**Mount Pleasant Open Cut Coal Mine - Modification 4 Rail Infrastructure (DA 92/97)
Flood Impact Assessment and Independent Review**

Rail Modification Flood Impact Assessment (MOD 4)

Rail Modification Flood Impact Assessment

The aim of this report is to provide an independent desktop review of the WRM Report 0744-01-K4, dated 29 May 2020 and titled: Pleasant Rail Loop Stage 2 – Rail Modification Flood Impact Assessment Report. The aim of the Flood Impact Assessment Report (WRM, 2020) was to assess the potential impacts of the proposed rail spur on Hunter River and to determine if the final design meets the performance criteria specified in condition 44C of the MOD4 consent. The WRM (2020) flood impact assessment report includes detailed hydrologic and hydraulic modelling of the Hunter River floodplain in the area of interest, which is used to assess the potential impacts of the proposed rail spur on flood levels and velocities.

Figure 3-6: Comparison of WRM (2020) 1% AEP Design Flood Level to RHDHV (2017)

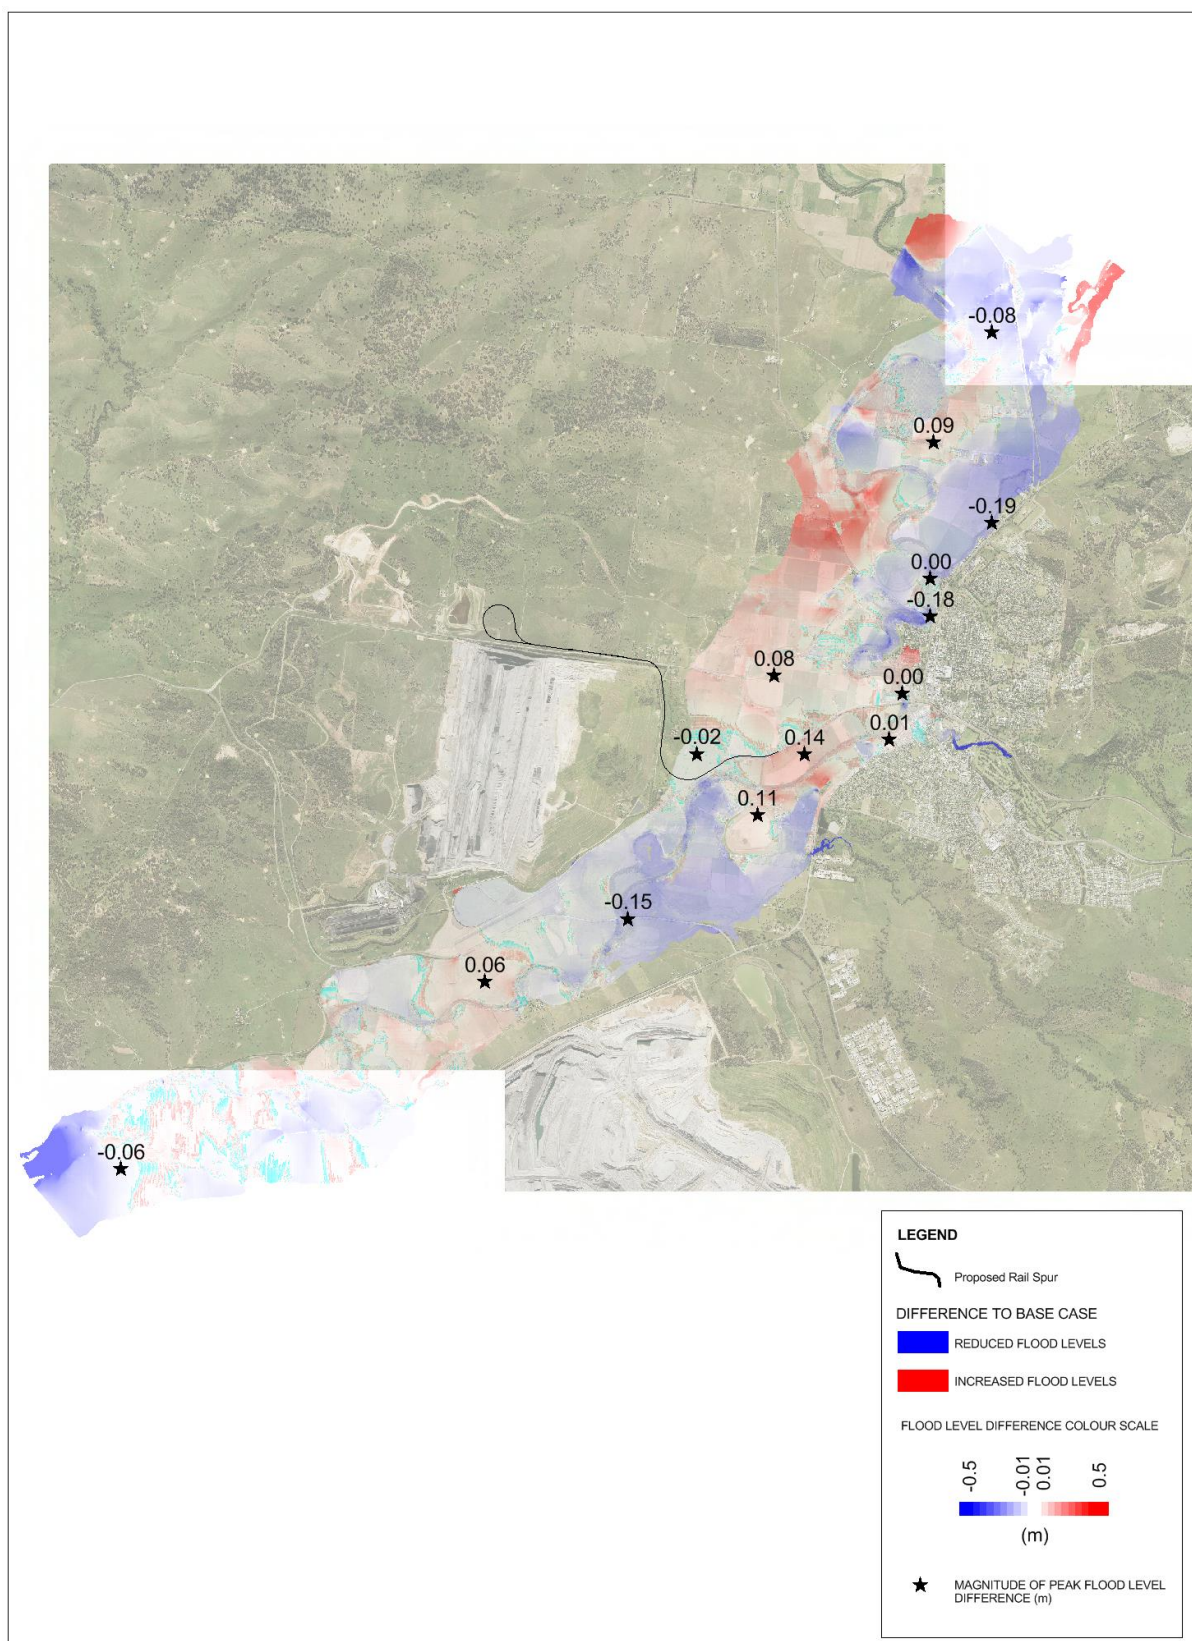
For the purpose of this review, gridded model results were also provided by WRM for comparison to the equivalent RHDHV (2017) model results. A map showing the difference in 1% AEP (i.e. 100-year ARI) peak water levels between the two models is presented in Figure 3-6 while a graph presenting the statistical difference in water level predictions between the two models is presented in Figure 3-7. In both figures, a positive value is where the WRM (2020) modelled water level is higher than the RHDHV (2017) modelled water level.

Figure 3-7: Statistical Comparison of WRM (2020) 1% AEP Design Flood Level to RHDHV (2017)

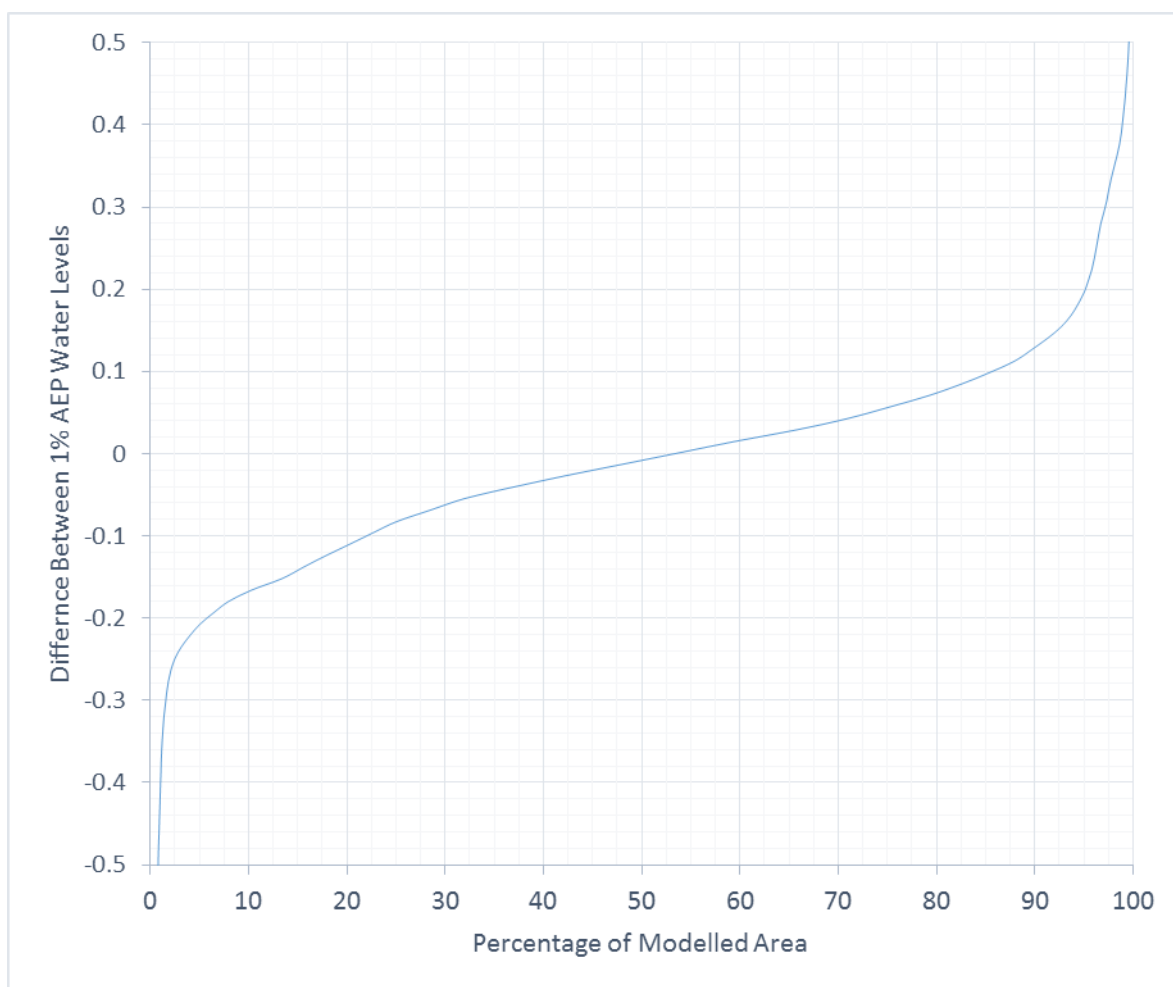
From an examination of the statistical difference in water level predictions (Figure 3-7) there is good overall agreement between the two models with virtually no bias in results present. The analysis shows that approximately 65% of the modelled area lies within $\pm 0.1\text{m}$ of the RHDHV (2017) model 1% AEP results and that 80% of the modelled area sits within the range -0.15 to 0.12m of the RHDHV (2017) model 1% AEP result. Less than 5% of the modelled area is associated with water level differences $\pm 0.3\text{m}$.

Figure 3-8: Peak flood level impacts, 1% AEP design event (Fig 6.5 WRM (2020))

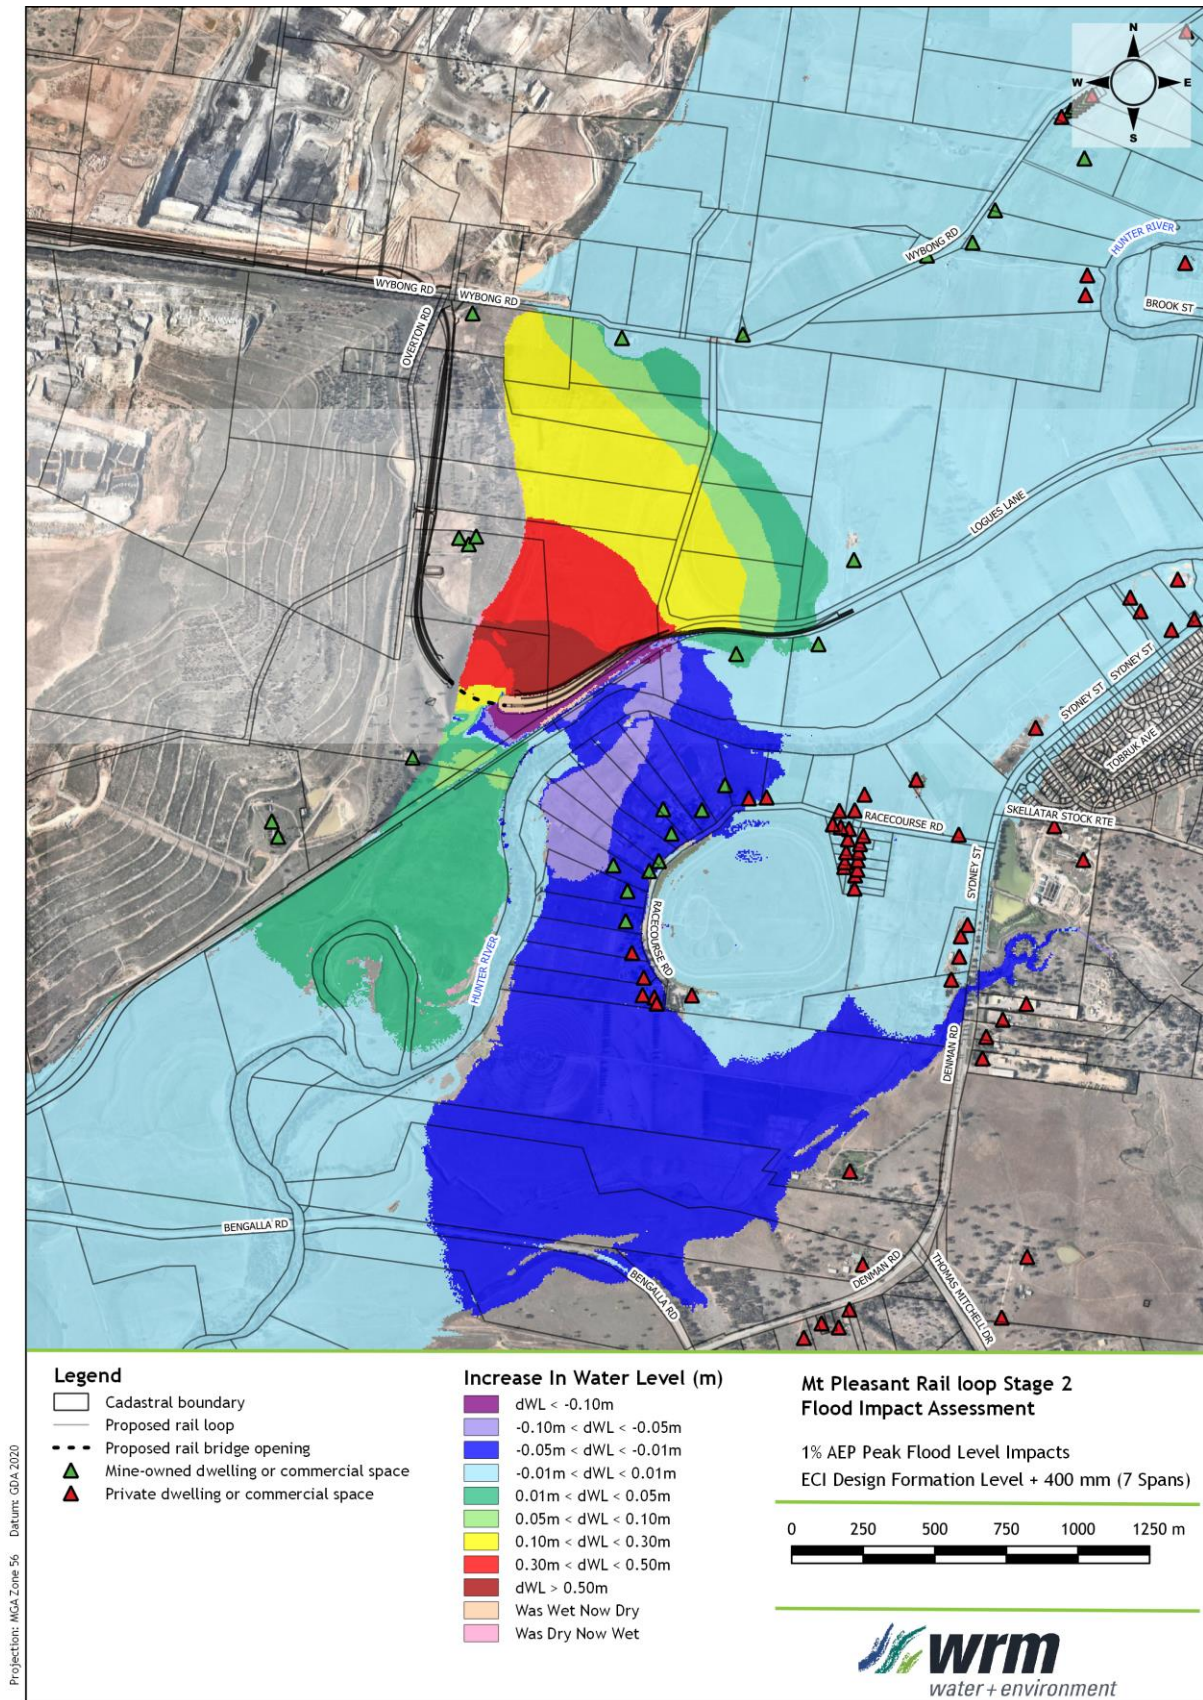
Figure 3-8 show the predicted flood level impacts while Figure 3-9 shows the predicted velocity impact for the 1% AEP design event. The resulting afflux appears consistent with the partial blockage of the floodplain, while the increase in velocity is associated with accelerated flow through the proposed bridge openings. The results show that the concept design meets the specified MOD4 design criteria which are clearly detailed in Section 6.4 of WRM (2020).

Figure 3-8 showed the predicted flood level impacts while Figure 3-9 showed the predicted velocity impact for the 1% AEP design event. The resulting afflux appears consistent with the partial blockage of the floodplain, while the increase in velocity is associated with accelerated flow through the proposed bridge openings. **The results indicate that the proposed design satisfies the specified MOD4 impact criteria defined in condition 44C.**

Figure 3-10: 1% AEP additional flood impact due to blockage (Fig 6.17 WRM (2020))

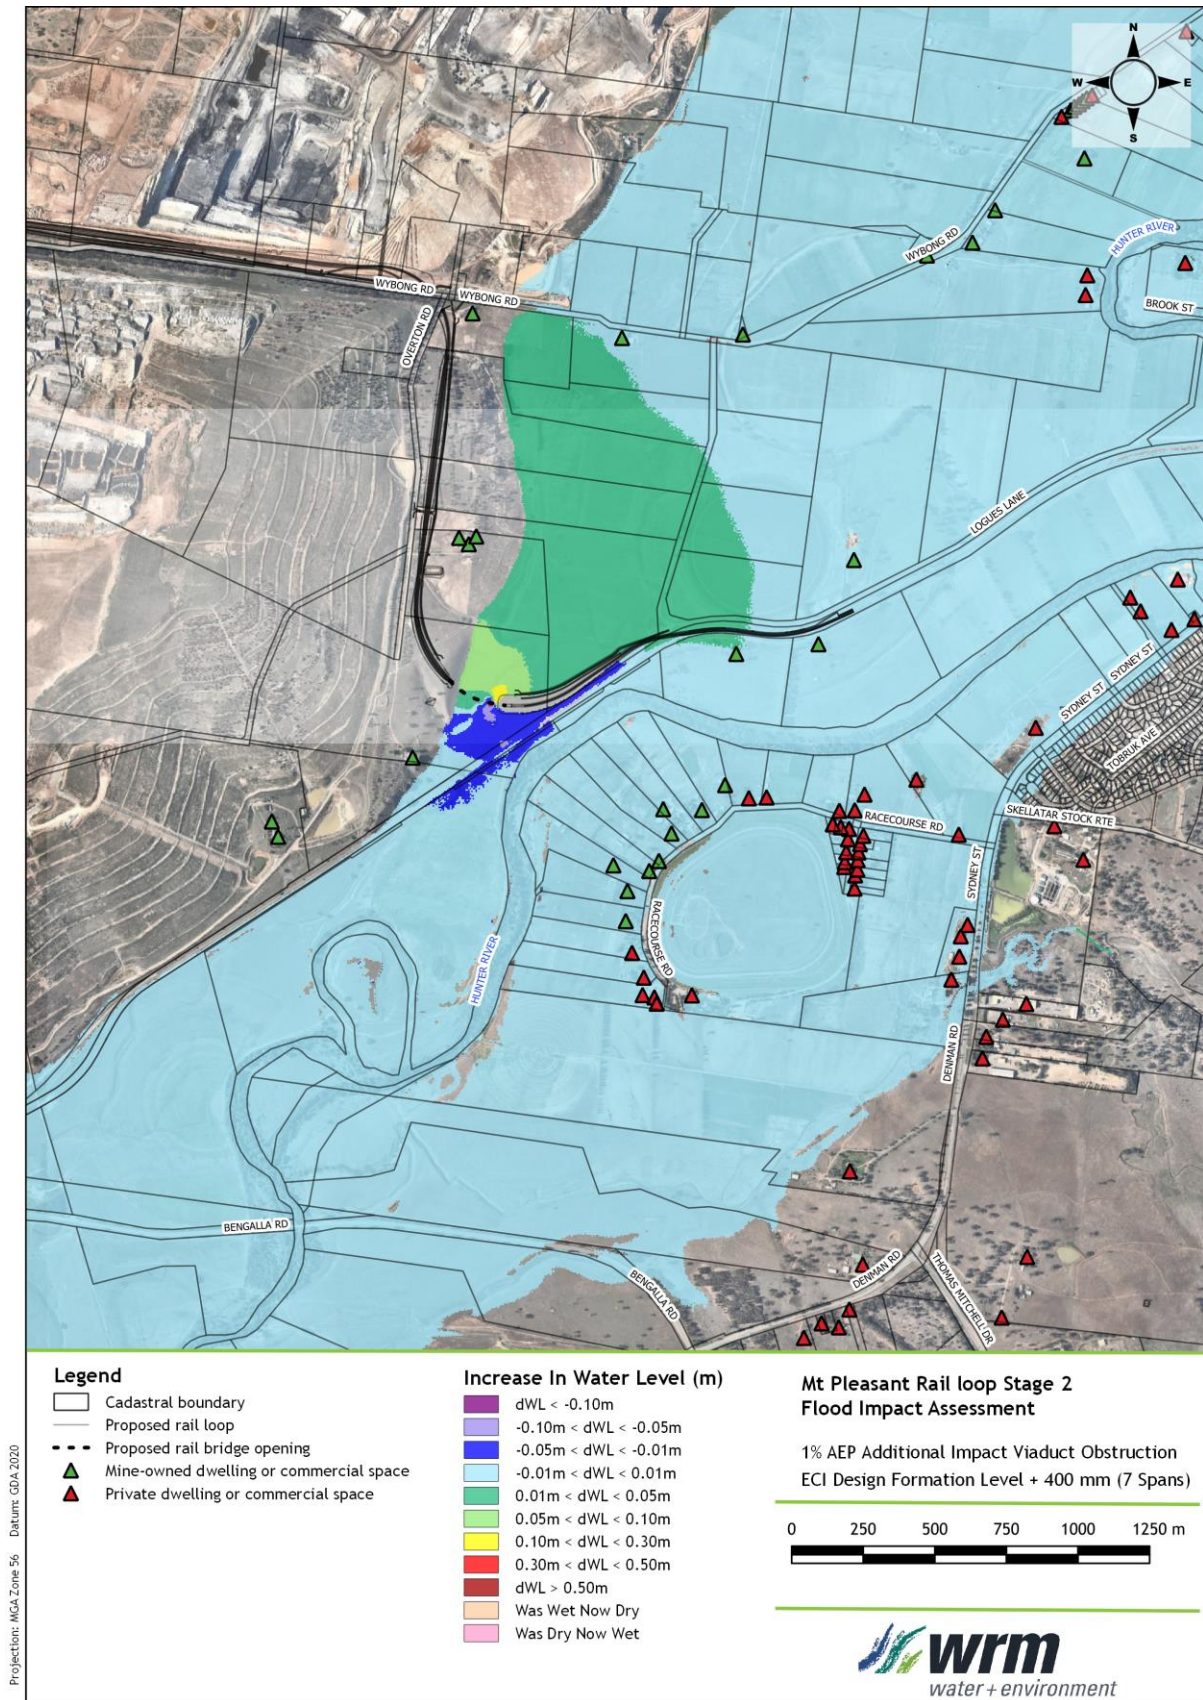
WRM provided an overview of the initial ARR 2019 blockage assessment in WRM (2020) Section 5.4.5 (as presented below in italics). It appears appropriate given the large size of the openings and the location of the proposed bridging elements on shallow areas of the floodplain located a significant distance from the main Hunter River channel. The inclusion of a 20 m wide pier blockage in WRM (2020) Section 6.7, allows the impact of a large blockage to be assessed. Figure 3-10 show the predicted additional flood level impact of 20m pier blockage. It should be noted that the total flood impact is the sum of the impacts presented in Figure 3-8 and Figure 3-10. It shows that while an additional flood impact of up to 5cm is modelled for approximately 1 km upstream of the proposed viaduct, the additional impact at Wybong Road is less than 1 cm, which shows that the MOD4 consent conditions would still be met, even if pier blockage occurred.
